**1.0 APPLICATION SUMMARY**

**Applicant:** Potomac Land Company  
**FLU Category:** RES-4  
**Service Area:** Urban  
**Site Acreage:** 15.014 acres  
**Community Plan Area:** Brandon  
**Overlay:** None

PETITION NO: MM 26-0553

<b>Unincorporated Hillsborough County Rezoning Consistency Review</b>	
<b>Hearing Date:</b> June 22, 2026 <b>Report Prepared:</b> June 11, 2026	<b>Case Number:</b> MM 26-0533 <b>Folio(s):</b> 88026.0000 <b>General Location:</b> North side of Loma Vista Drive and Hide-Away Lane intersection, southwest of Lithia Pinecrest Road
<b>Comprehensive Plan Finding</b>	<b>INCONSISTENT</b>
<b>Adopted Future Land Use</b>	Residential-4 (4 du/ga; 0.25 FAR)
<b>Service Area</b>	Urban
<b>Community Plan(s)</b>	Brandon
<b>Rezoning Request</b>	Major Modification (MM) to Planned Development (PD) 19-1344 to develop 55 dwelling units
<b>Parcel Size</b>	15.01 ± acres
<b>Street Functional Classification</b>	Hide-Away Lane – <b>Local</b> Lithia Pinecrest Road – <b>Arterial</b>
<b>Commercial Locational Criteria</b>	N/A
<b>Evacuation Area</b>	N/A

2.5 Proposed Site Plan (partial provided below for size and orientation purposes. See Section 8.2 for full site plan)

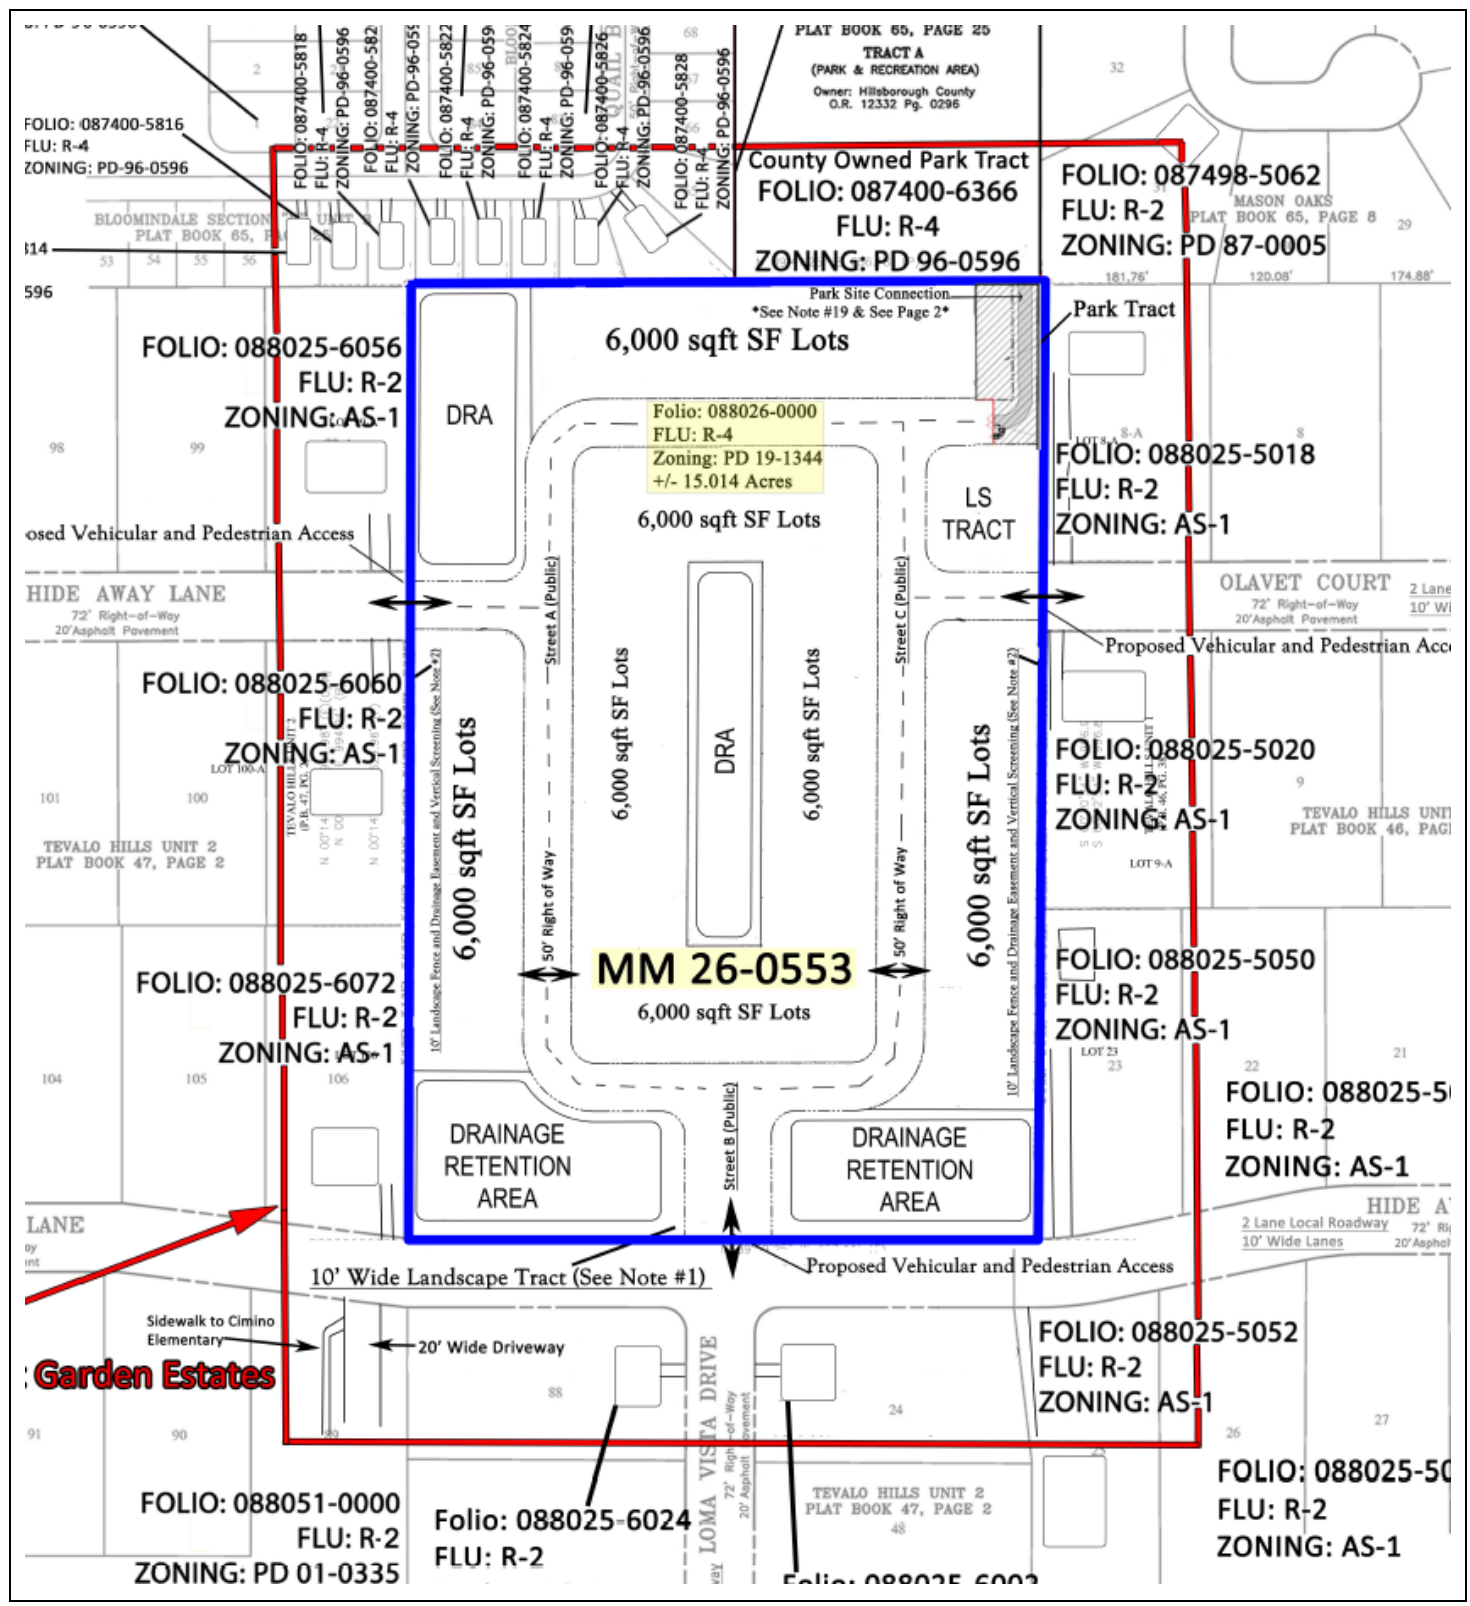
The major modification seeks to increase the number of single-family lots from 34-lots to 55-lots and decrease the minimum lot size from 10,000 square feet to 6,000 square feet. Naturally, the side yard setback has been reduced to 5 feet, and the minimum lot width has been reduced to 50 feet.

The subject property is situated in a residential area made up primarily of one (1) acre or larger lots to the east, west, and south, while smaller lots are located adjacent to the north and are approximately 4,000 square feet or larger in size. With the proposed reduction in minimum lot width (from 75' to 50') and lot size, the majority of the additional lots will be internal to the project and along the northern boundary where there are similar adjacent lot sizes. Along the eastern and western boundary adjacent to the larger 1 acre lots, based on the difference/change in minimum lot widths the number of lots along each of these boundaries will increase by approximately 3-4 additional lots. To minimize impacts to the surrounding neighborhood, the previous approval provided a 10' landscape easement screening area with a 6' fence and planted trees every 40 feet along the eastern and west boundaries. This application enhances the easement screening area by providing a 6' fence and planted trees 3" caliper 10-foot-high trees every 20 feet. The Land Development Code does not require screening and buffering between single-family uses, regardless of differences in lots sizes. The proposed screening treatment of a 6-foot-high fence and 10-foot-high trees planted every 20 feet is equivalent to screening treatment for those two elements that would be required by the Land Development Code if office or commercial uses were proposed adjacent to the existing single-family lots. Additionally, the 30' rear yard setback will remain in place for homes along these boundaries. Along the southern boundary, water retention areas take up much of the area and a 125-foot building setback is proposed.

While the development proposes a higher density residential development within a lower density neighborhood, the proposed density (3.66 units per acre) complies with underlying RES-4 Future Land Use (FLU) classification (max 4 units per acre) and the adjacent residential to east and west is RES-2 FLU (max 2 units per acre), therefore, Development Services concludes that proposal to increase the density of the development is supported by the enhancement of the east/west buffer, the proposed emergency access, and the addition of a second traffic light at the intersection with Lithia-Pinecrest Road and Adelaide Avenue. As a result, Development Services does not foresee any compatibility concerns with the proposed Planned Development.

Based on the above considerations, staff finds the proposed Major Modification, subject to the conditions, approvable.

8.2 Proposed Site Plan (Page 2 of 2)

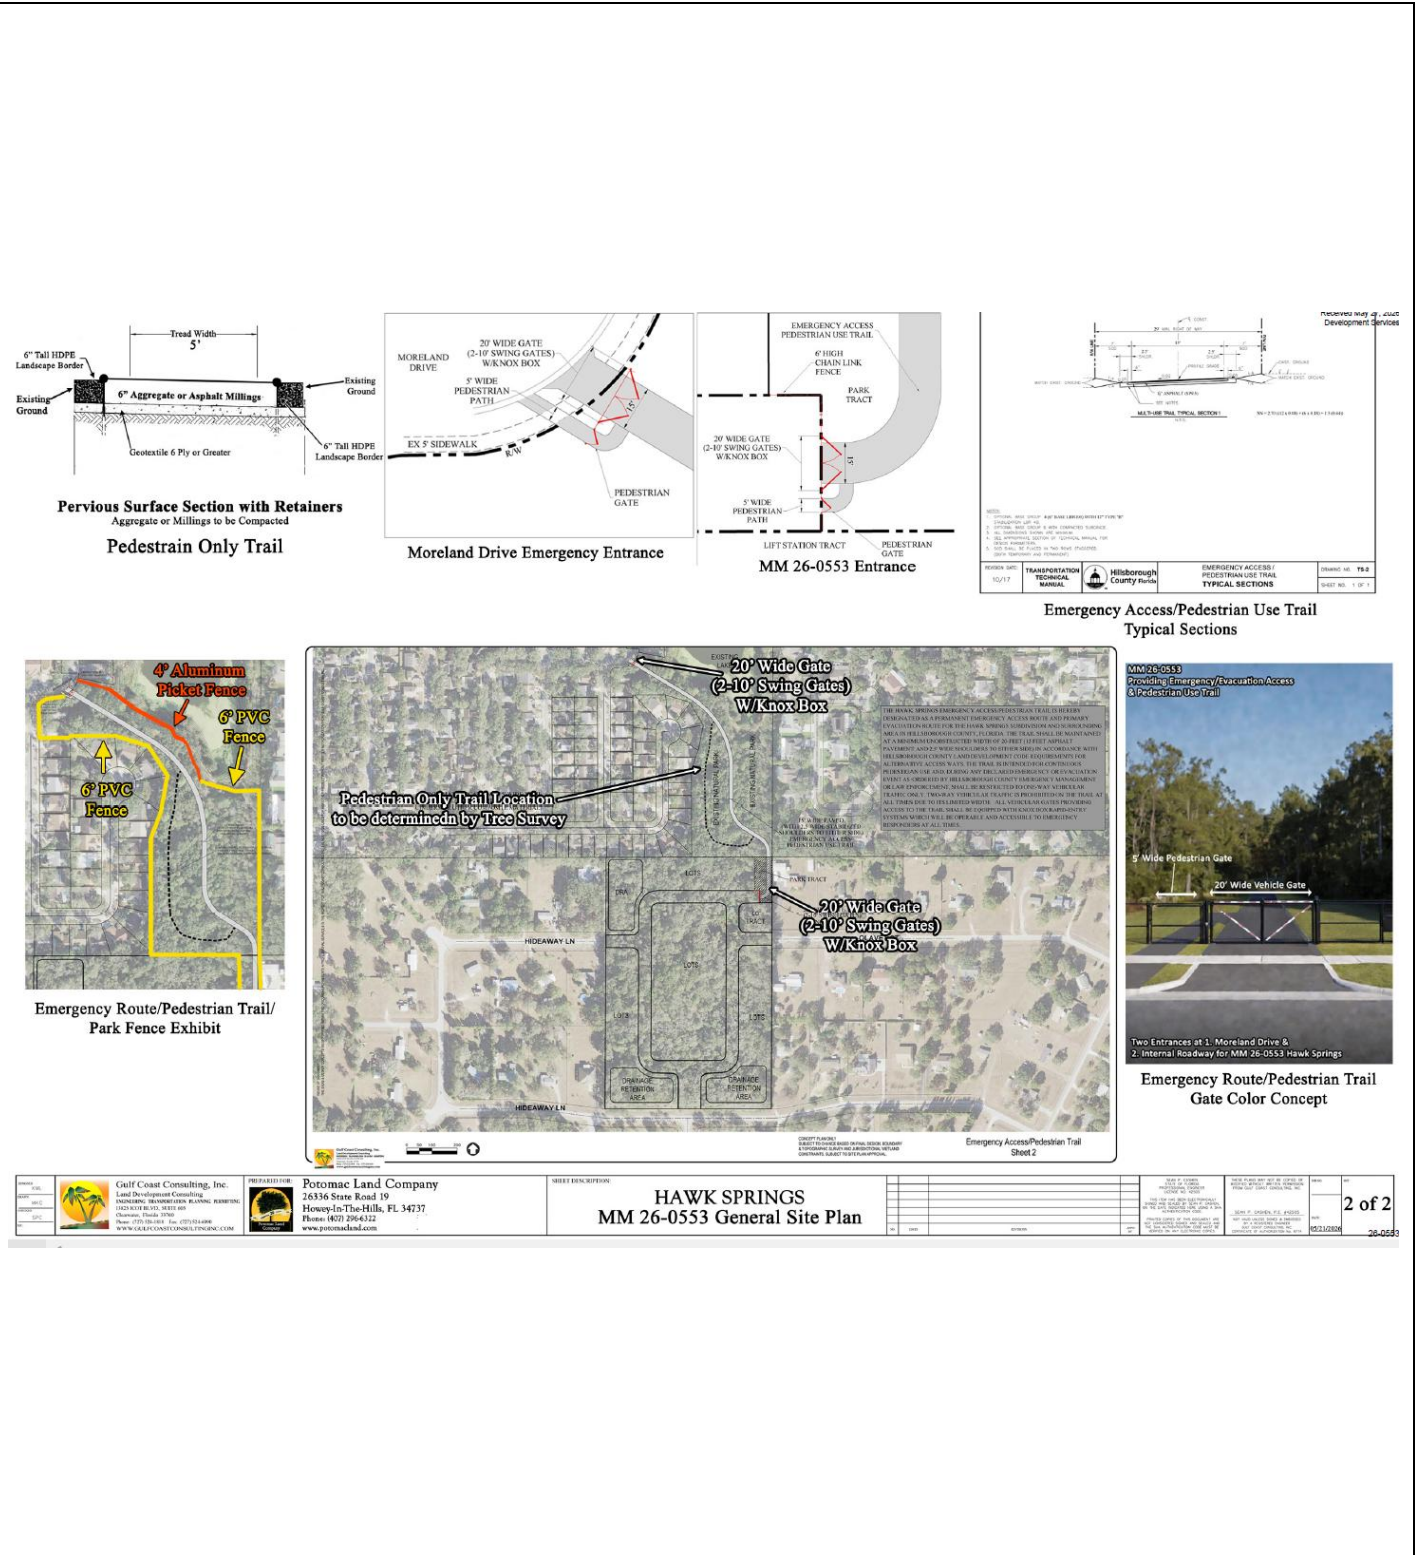
In addition to the lot size and density concerns, the proposed site plan does not promote the level of neighborhood integration contemplated by the Comprehensive Plan. FLUS Policy 4.4.2 states that neighborhoods shall be designed to include an efficient system of internal circulation and street stub-outs to connect adjacent neighborhoods. Similarly, Mobility Goal 4 seeks to provide safe and convenient connections within the transportation network, while Mobility Objective 4.1 promotes the design of urban and suburban communities around a grid or modified grid street network that improves interconnections between neighborhoods and surrounding neighborhood-serving uses. Although the subject property is located within the existing Tavallo Hills neighborhood, the proposed development remains largely isolated from the surrounding street network and does not provide meaningful opportunities for connectivity to adjacent residential areas. As a result, the development functions as a self-contained subdivision rather than an integrated component of the surrounding neighborhood structure. This lack of connectivity is inconsistent with the Comprehensive Plan's objectives of promoting interconnected neighborhoods, coordinated residential development patterns, and a connected transportation network.

Therefore, while the proposed residential use and overall density remain generally consistent with the Residential-4 Future Land Use designation, the reduction in lot size from 10,000 square feet to 6,000 square feet and the increase in unit count from 34 to 55 dwelling units are inconsistent with FLUS Policy 3.1.3, FLUS Objective 4.4, FLUS Policy 4.4.1, and the goals and policies of the Brandon Community Plan related to preserving the character of the Garden Estates District. Accordingly, staff finds the proposed Major Modification inconsistent with the Comprehensive Plan.

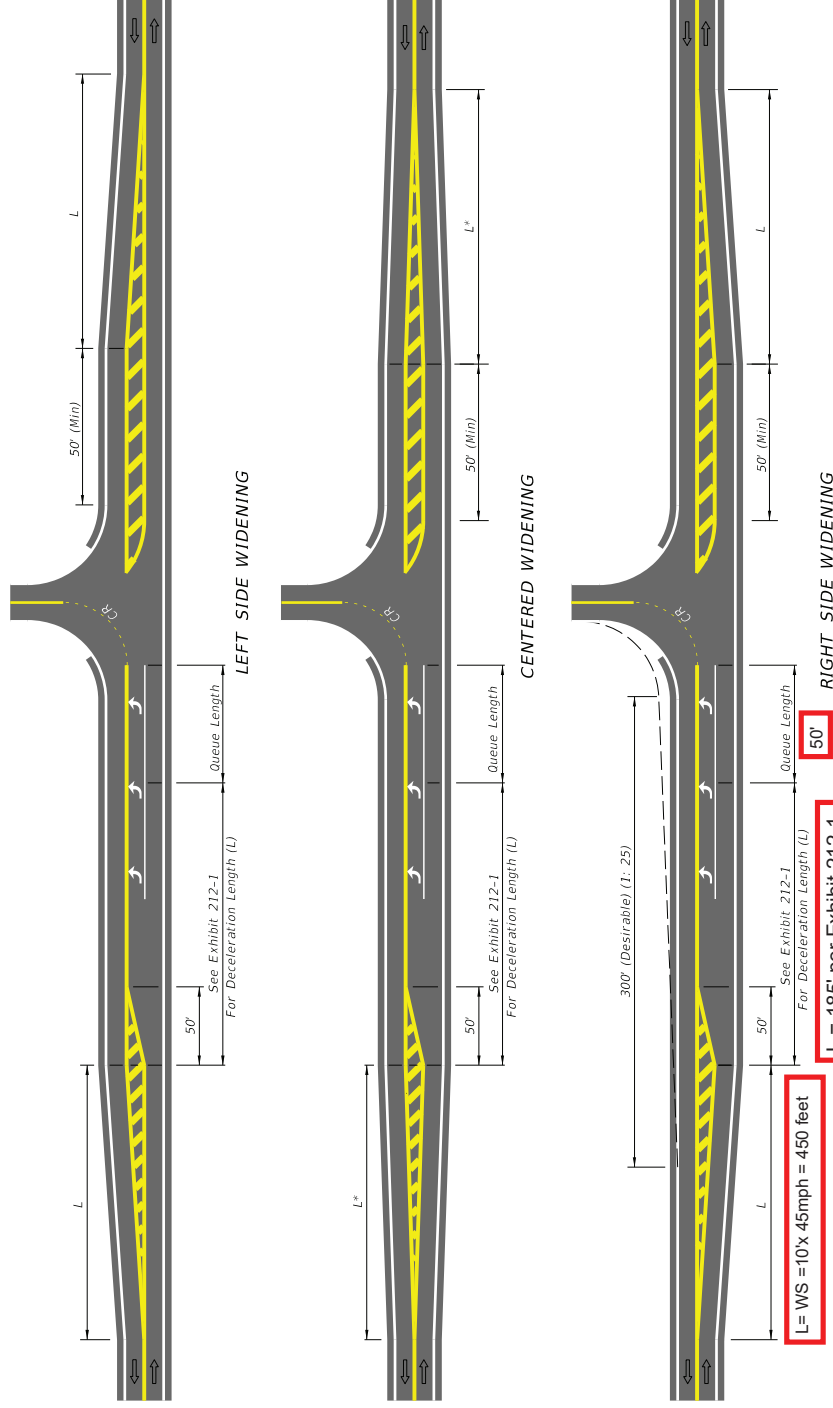
- The developer shall construct a southbound to westbound right turn lane at the intersection of Lithia Pinecrest Rd. and Adelaide Ave. with the initial increment of development.

- If PD 26-0553 is approved, the County Engineer will approve a Design Exception (dated June 16, 2026) which was found approvable by the County Engineer (on June 16, 2026) for the existing northbound to westbound left turn lane on Lithia Pinecrest Rd. As the existing turn lane does not comply with the minimum required turn lane length, the Design Exception will allow the turn lane to remain as is.

# Sidewalk Exhibit

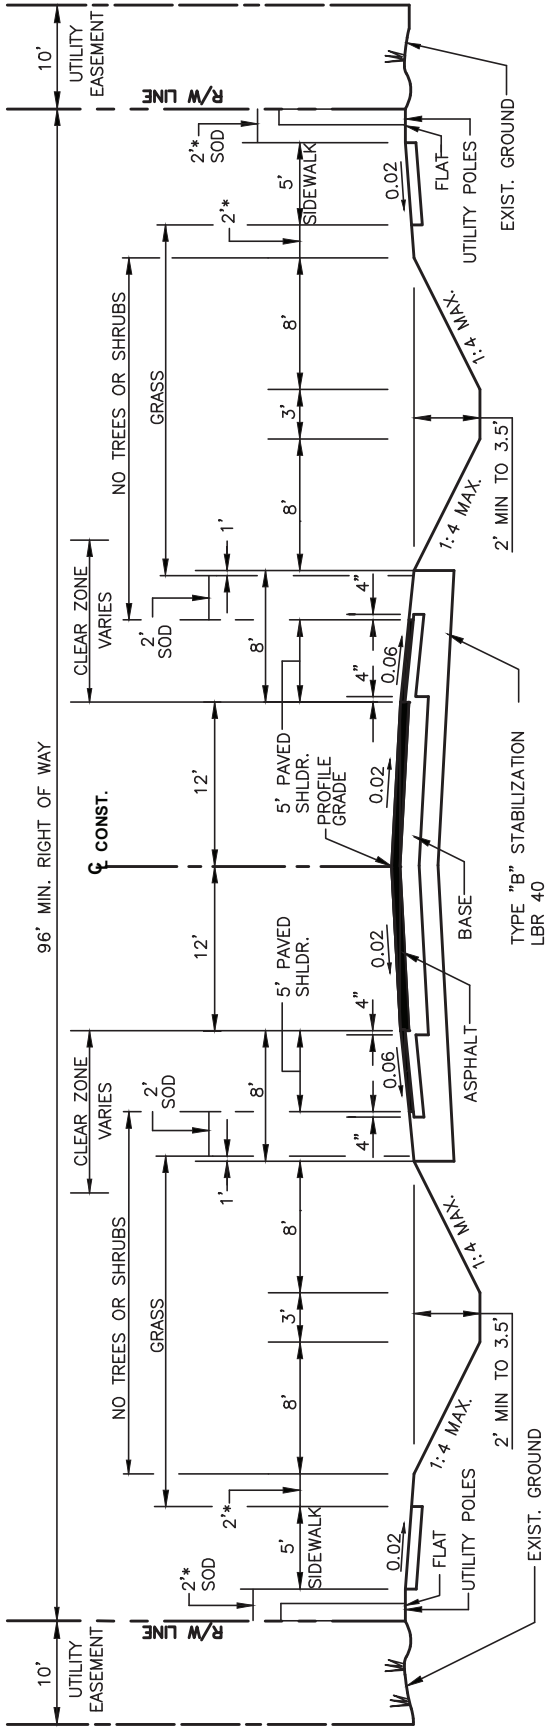
- If PD 26-0553 is approved, the County Engineer will approve a Design Exception (dated June 15, 2026) which was found approvable by the County Engineer (on June 16, 2026) for improvements to Olavet Ct. and Hideaway Ln. As Olavet Ct. and Hideaway Ln. are substandard local roadways, the developer shall make certain improvements consistent with the Design Exception, including constructing a +/-140 feet of 5-foot-wide sidewalk and a crosswalk to connect the site to the existing sidewalk within Cimino Elementary School.

Elementary School. This sidewalk extension will provide a safe and continuous pedestrian access route from the project site to this school.
